ADDENDUM NO. 2

DATE OF ISSUANCE:	April 22, 2024
PROJECT:	2024 Addition and Renovations North Harrison Elementary School 1115 W. Whiskey Run Road Ramsey, IN 47166
OWNER:	North Harrison Community Schools
ARCHITECT'S PROJECT NO.:	23-228.001
ORIGINAL BID ISSUE DATE:	April 03, 2024

Sheet
AD-2A

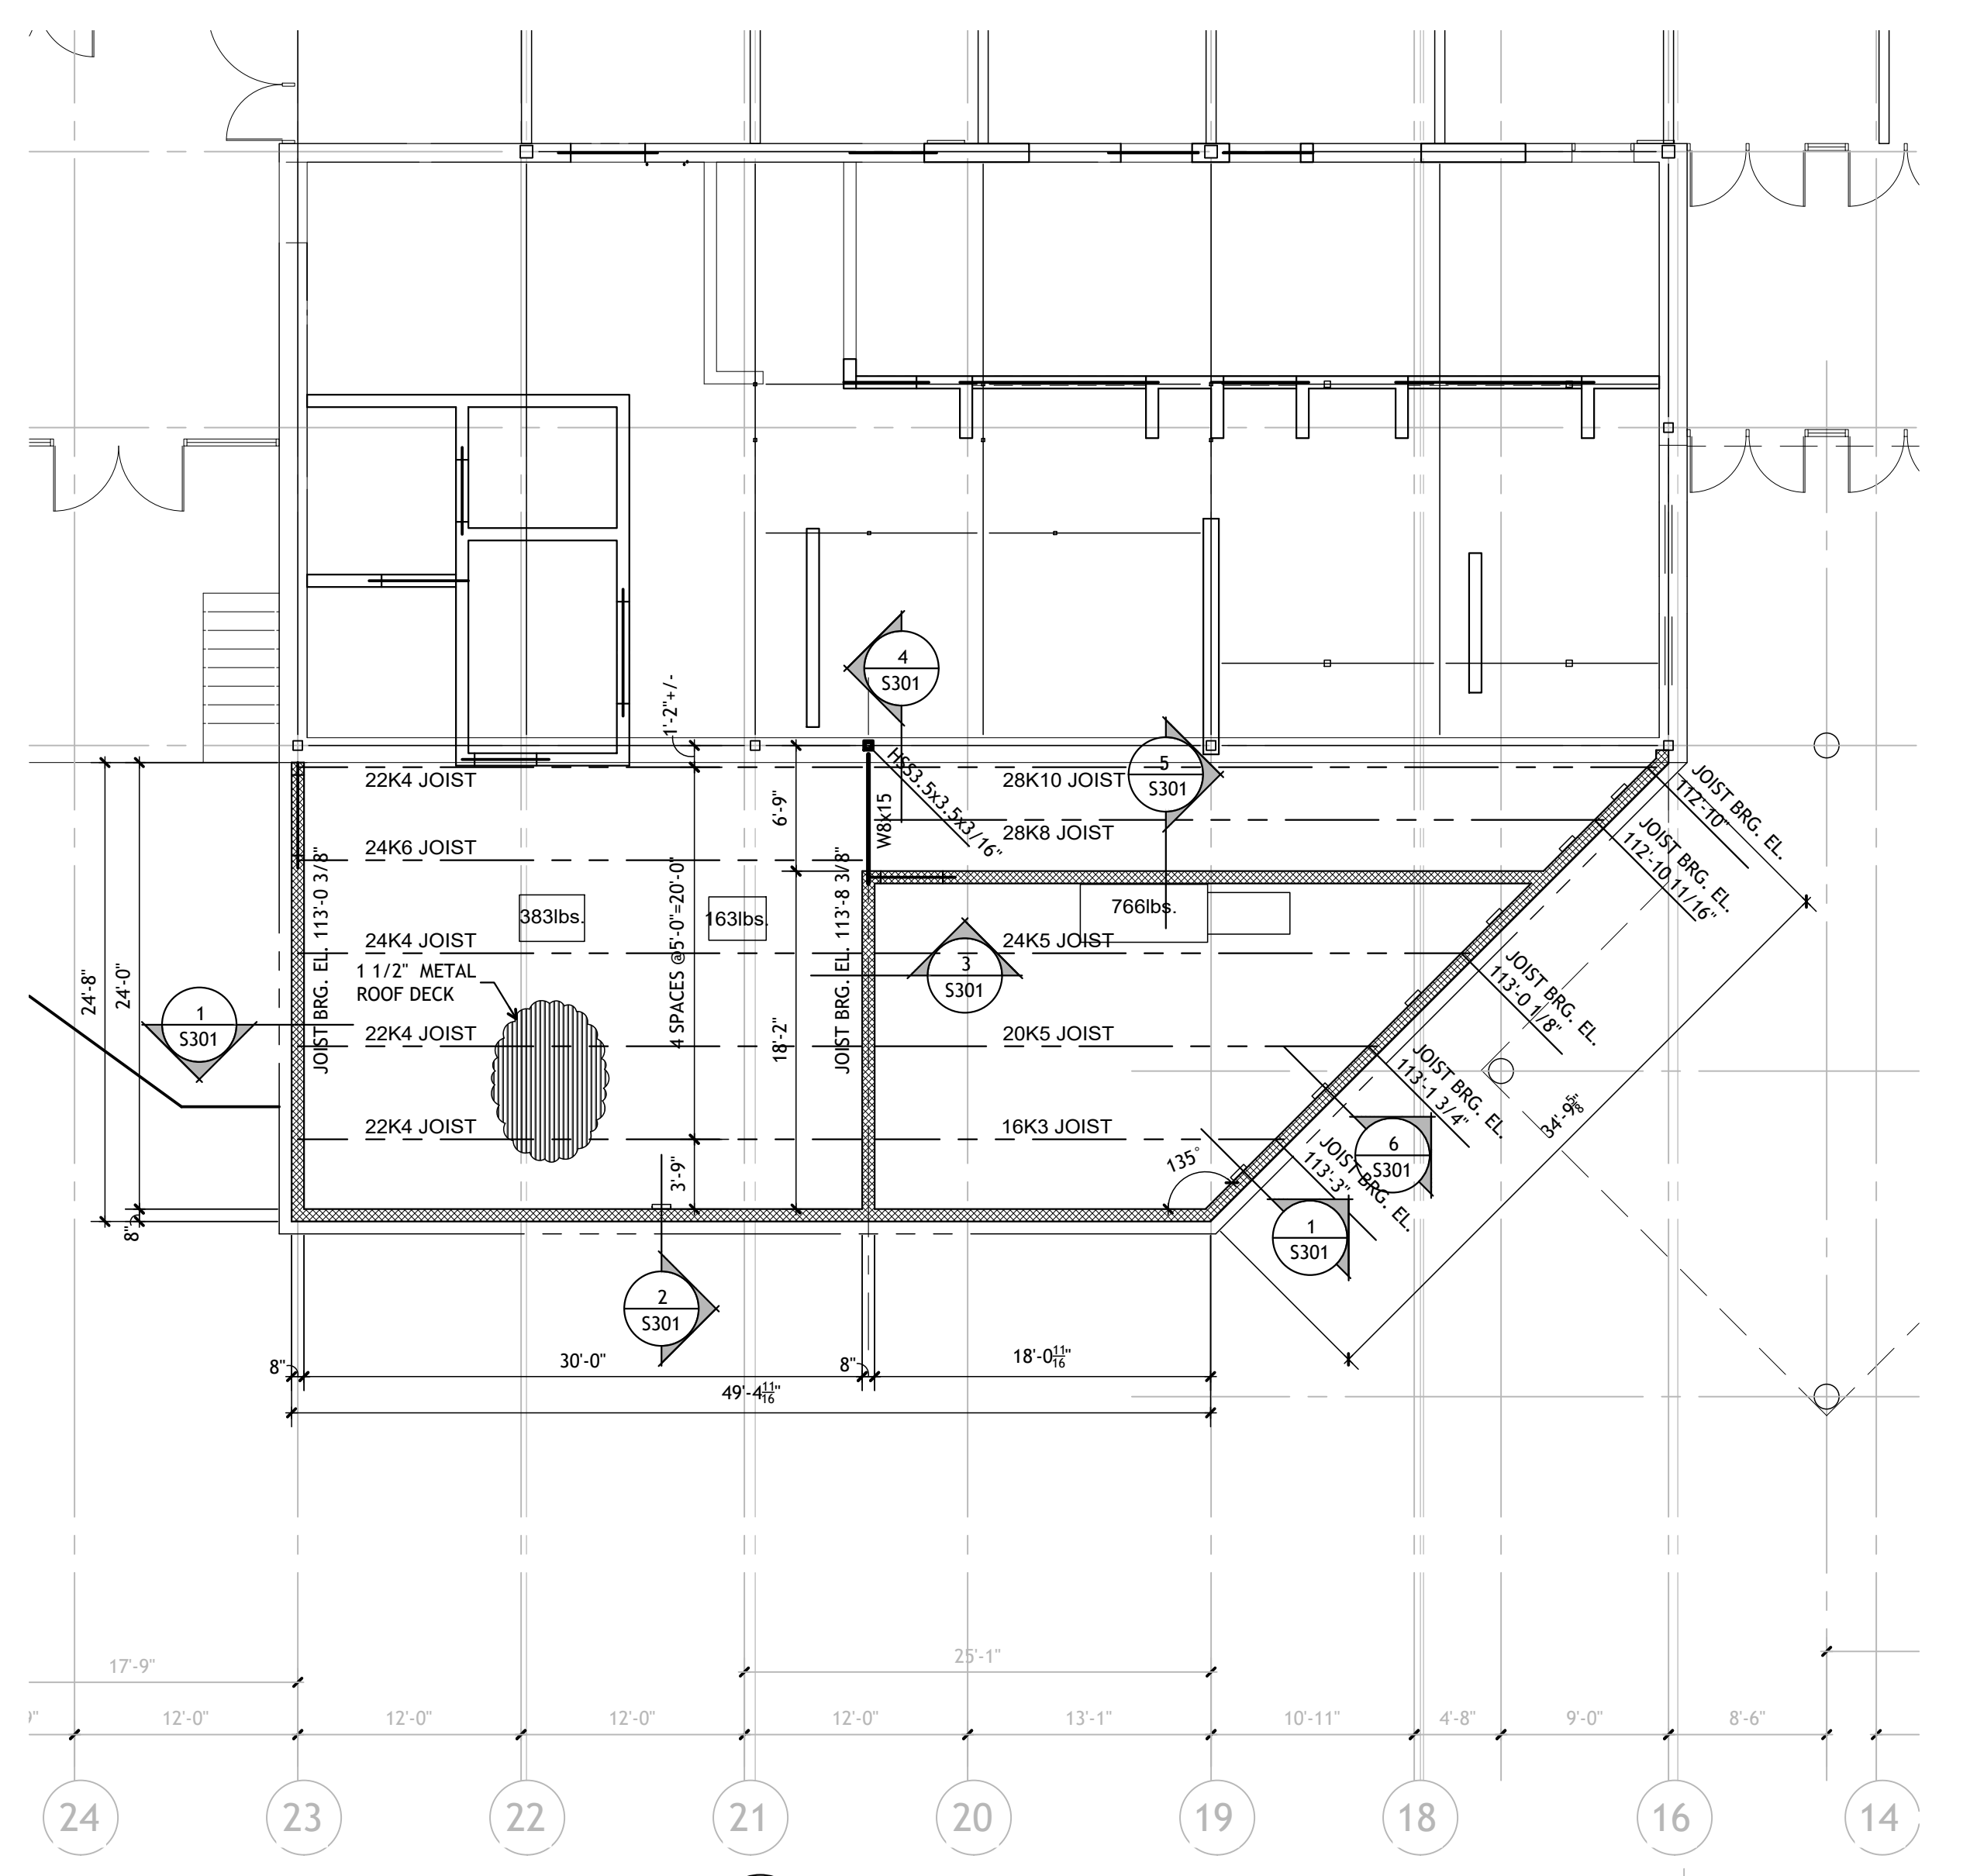
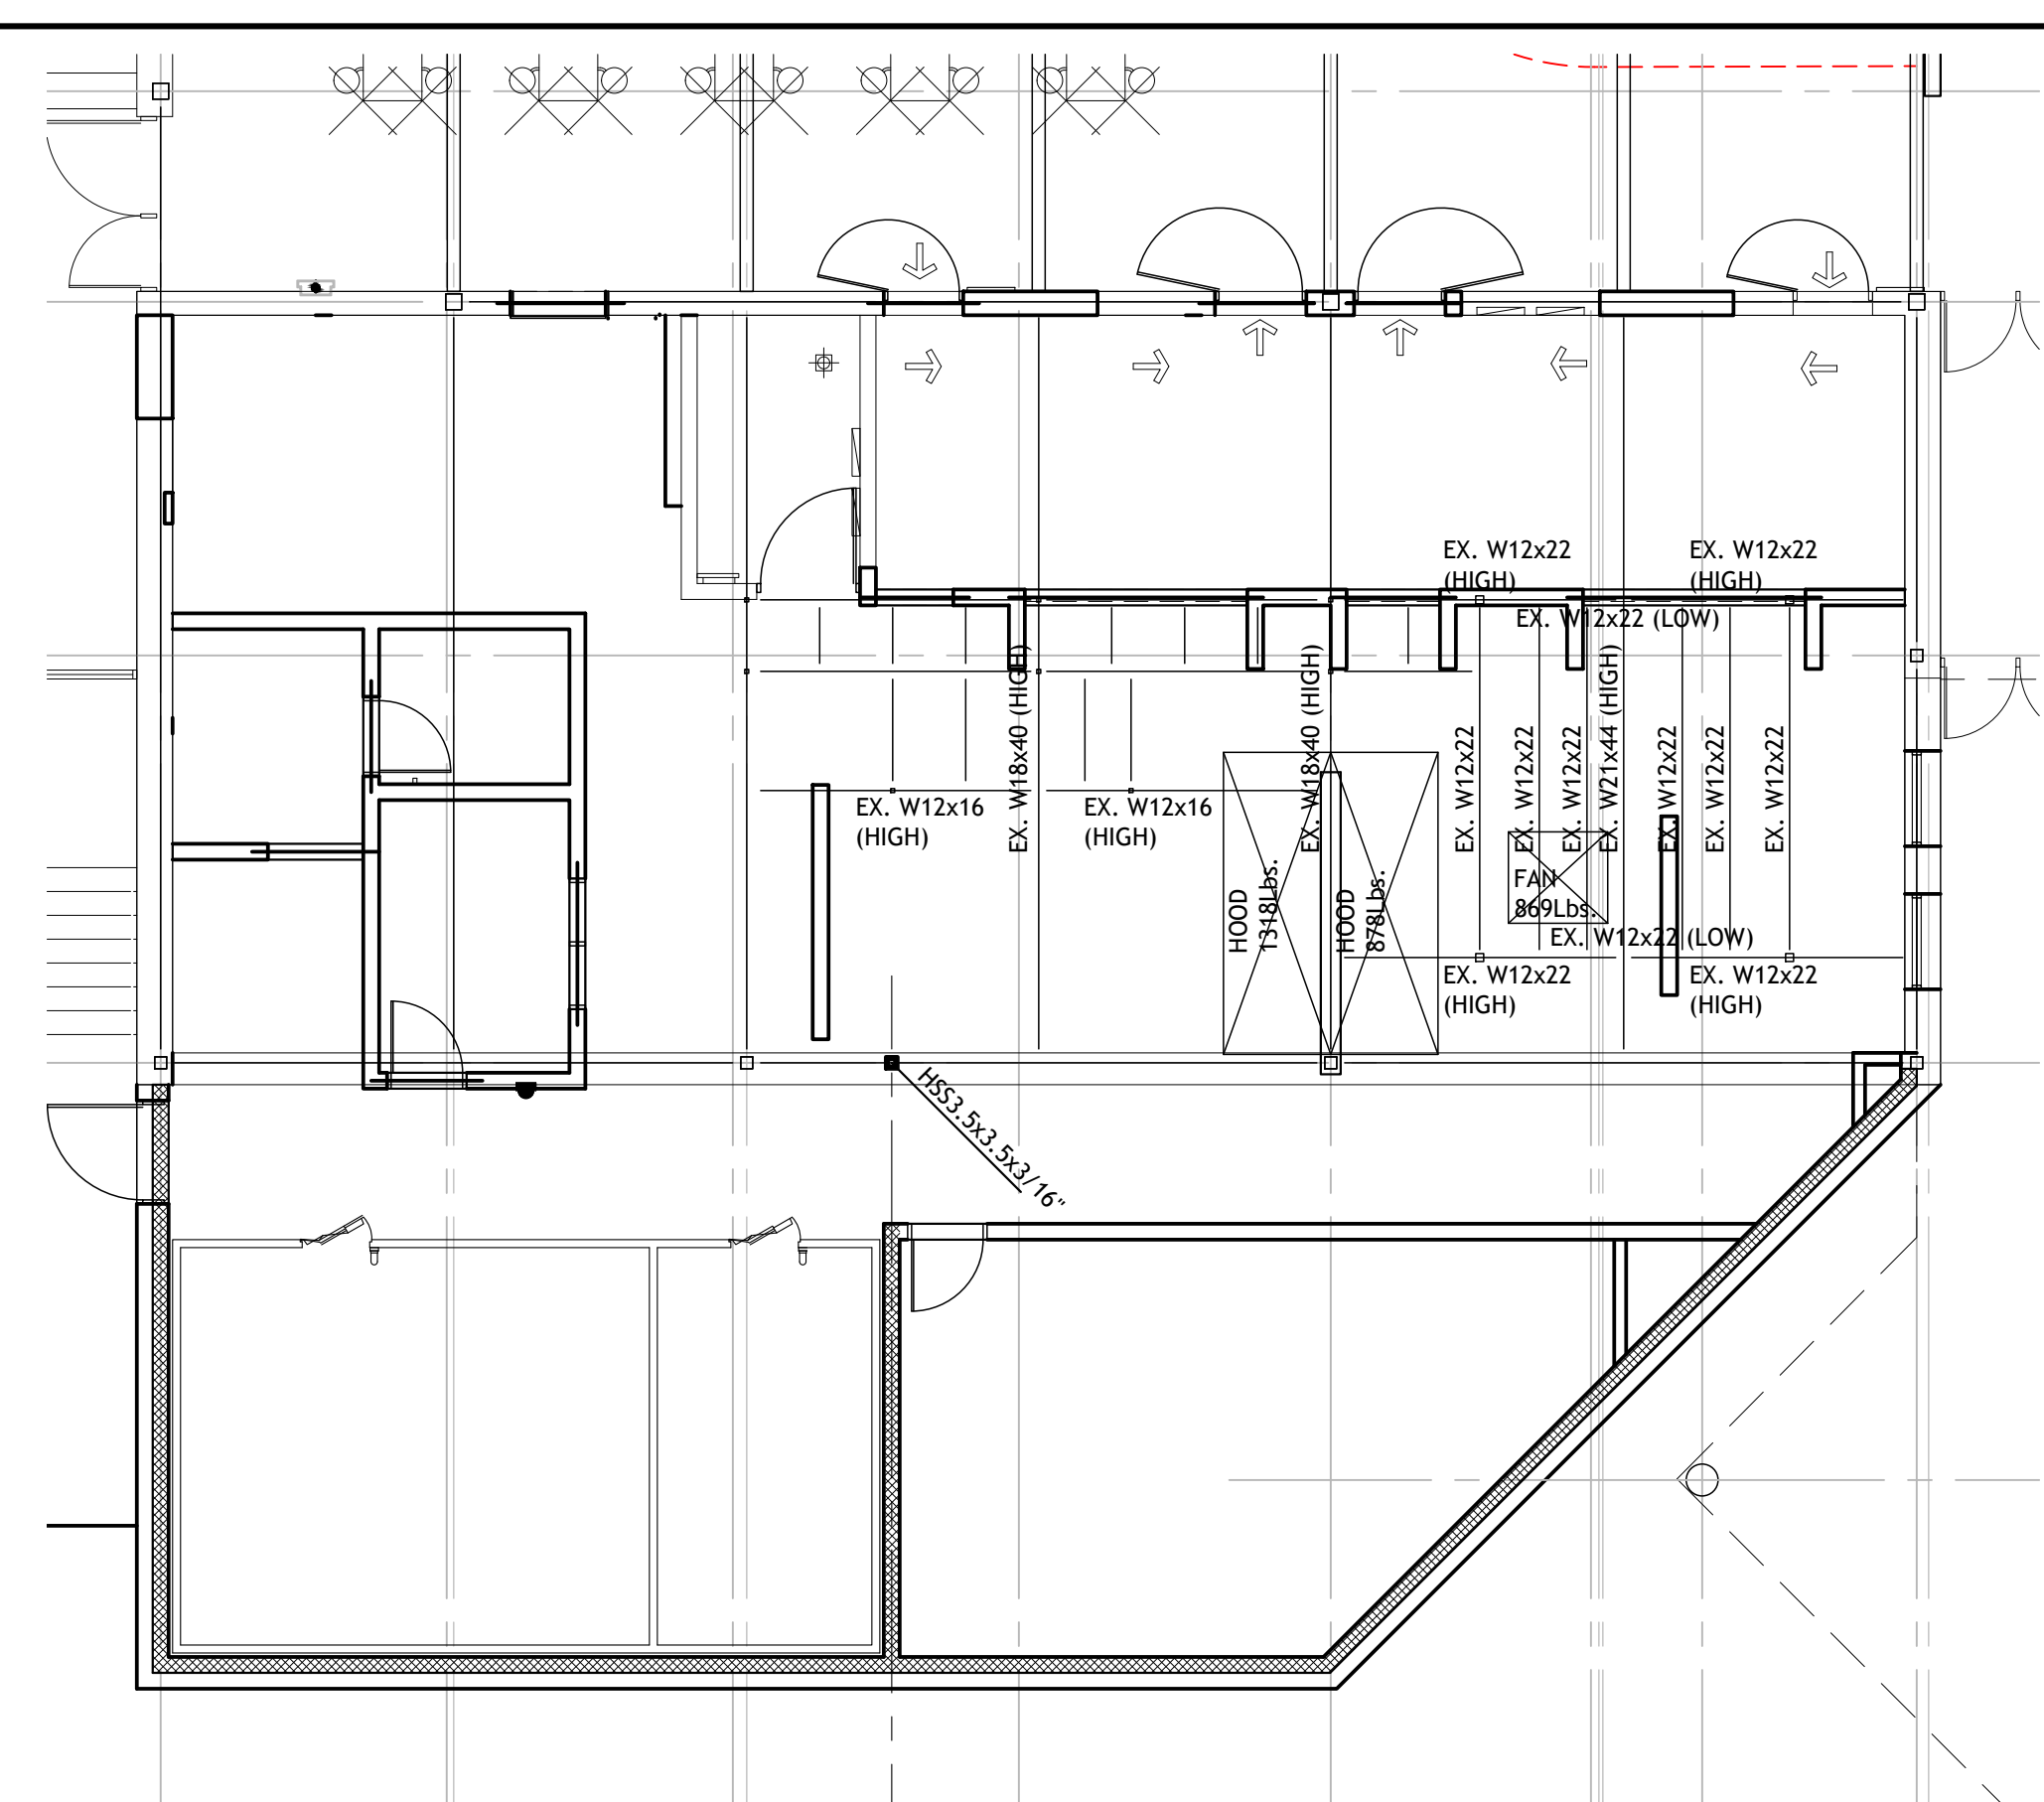
4. Contractor to provide a storage container for the duration of the project to secure Owner's existing kitchen equipment to be re-installed in the new kitchen. See attached Drawing AD-2A for tentative location and additional requirements.
